E5070A-08A**S E R V I C E****N O T E**Supersedes:
E5070A-08**E5070A ENA Series Network Analyzer, 300 kHz to 3 GHz****Serial Numbers: JP1KJ00001 to JP1KJ99999****When E5070A has the step attenuator (33321-60059) and fails Internal Test at Step Attenuator test group, replace the old step attenuator with the improved version (33321-60069) and the revised A86 (E5070-65086).****To Be Performed By: Agilent-Qualified Personnel or Customer****Parts Required:**

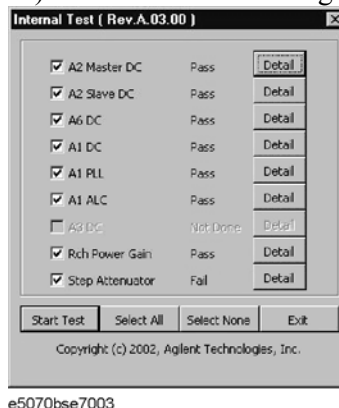
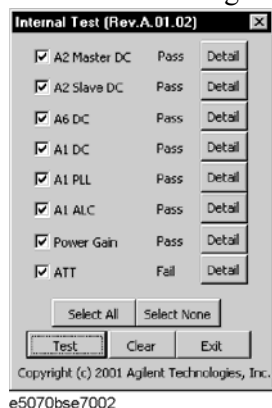
Internal Test is failed on Step Attenuator Test Group, due to the old attenuator reliability.

When the attenuator (33321-60059) is defective, replace with the new replacement attenuator (33321-60069, not 33321-60068) and replace A86 (E5070-66586) with revised one (E5070-65086). There is no need to upgrade firmware for this replacement.
